MIL-F-63446A (AR)
AMENDMENT 9
28 May 1991

SUPERSEDING
AMENDMENT 8
7 July 1989

FUZES, GENERAL PURPOSE GRENADE: M230 AND M231 (PRACTICE)

FIGURE 1. Defect Zones

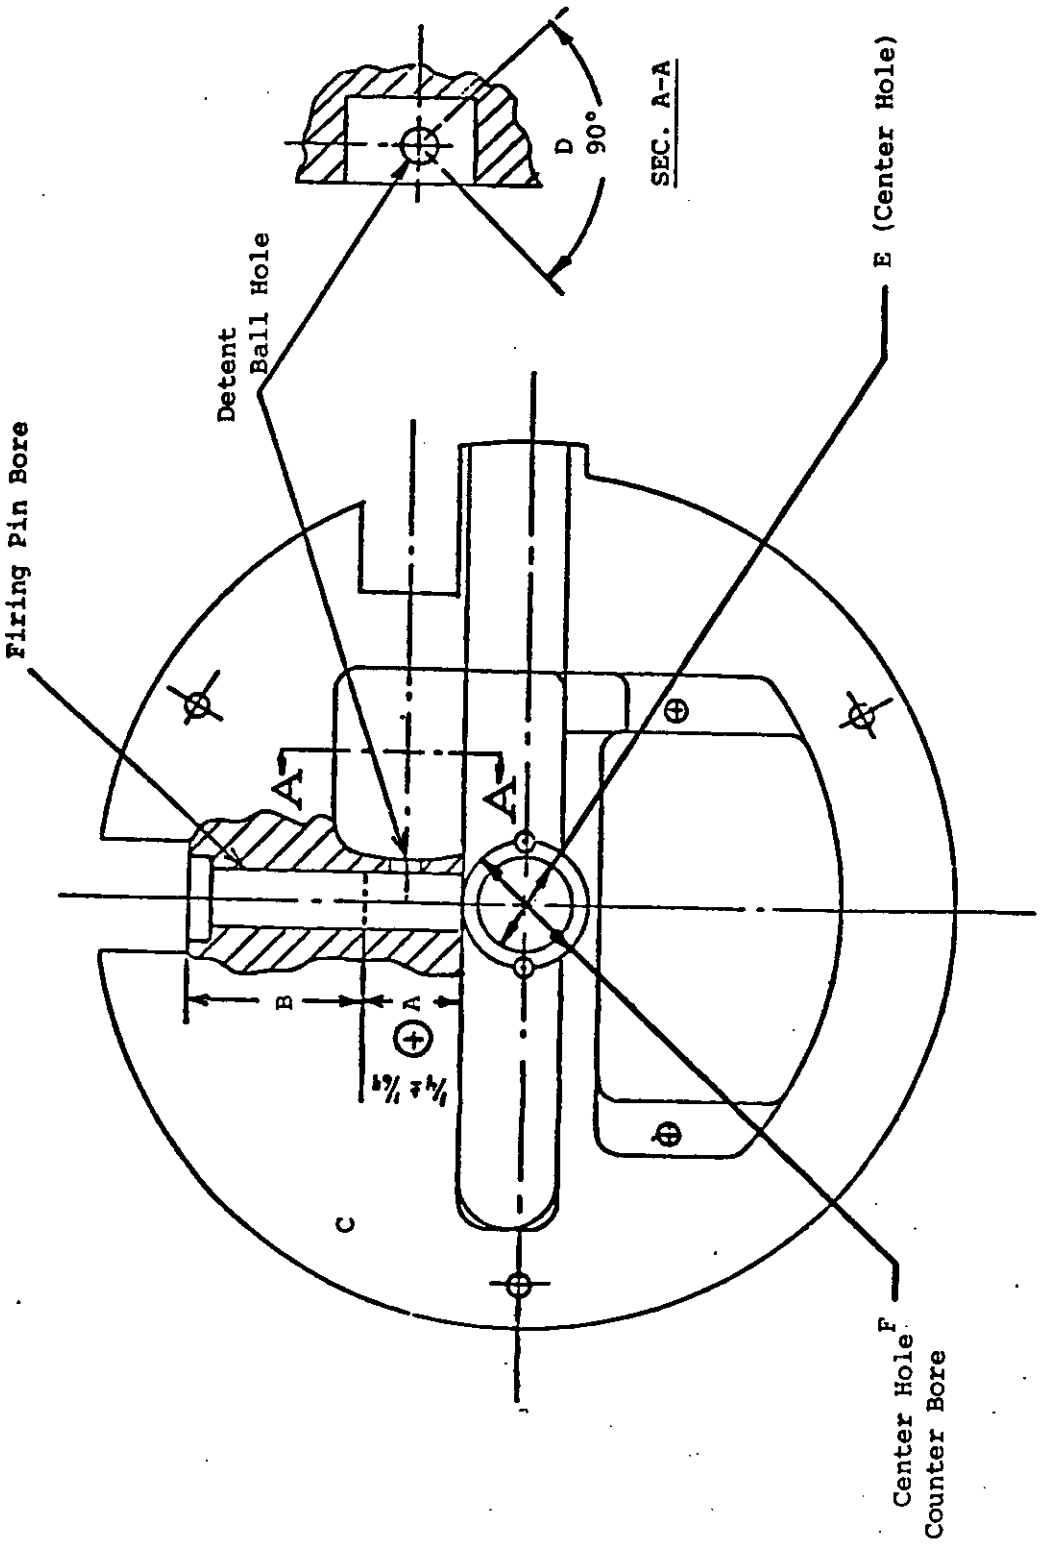
"4.5.1 Porosity check. A random sample shall be chosen from each cavity of an incoming lot of Fuze Body die cast blanks in accordance with the requirements of Table II of QQ-591. The castings shall then be machined to final configuration and inspected for size, location, depth and frequency of surface defects. The acceptable limit of defects is described in both Table II (attached) and Figure 1 (attached). If the number of rejects from a given cavity exceeds the AQL Level reported in Table II of QQ-591, the incoming quantity from that cavity may be either be rejected and removed from production or screened 100% after machining. A cavity, once pulled from production, cannot be used until requalified. Sectioning may be performed on any portion of the inspection sample if necessary. The firing pin bore shall be inspected 100% by using an Otoscope to direct light and magnify the image."

Add new Figure 1 included (75a).

ZONE A - The length of the firing pin bore (.158"+.003" in diameter) extending back from the slider slot a distance of 1/4" + 1/64" (see figure 1).

ZONE B - The length of the firing pin bore extending back from the end of ZONE A to and including all surfaces of the firing pin cap counterbore (.218"+ .003" diameter). (see figure 1).

ZONE C - All other surfaces of the casting excluding the detent ball hole (ZONE D) and the center hole counter bore (ZONE F).

ZONE D - The surface of the detent ball hole included within an arc of 90° the center of which is the nominal contact point of the detent ball (see figure 1).
